P 515328

A REPAIR

ON-SITE SEWAGE DISPOSAL SYSTEM HOWARD COUNTY HEALTH DEPARTMENT BUREAU OF ENVIRONMENTAL HEALTH

ADDRESS: 3080 Pfefferkorn Road PROPERTY OWNER: Jan Paper

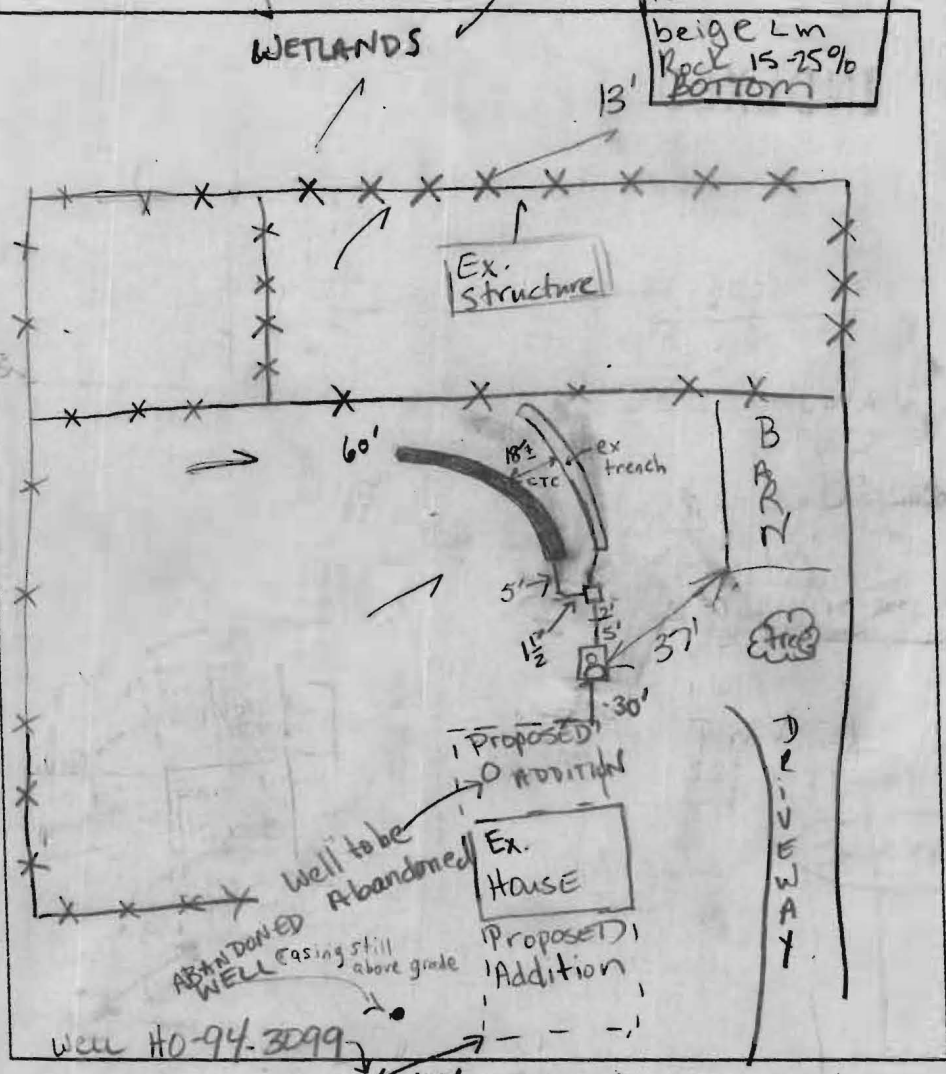
PRE-CONSTRUCTION INSPECTION: 11/16/01 OK TO START PER SPECS (KG/MR)

INSPECTION COMMENTS: "11/7/01 Follow up. REQUEST MANHOLE ON BACK. OK TO COVER TRENCH. (KG/SK) 11/15/01- CONN. TO ADDITION MADE, OK TO COVER WORK - (SRM)
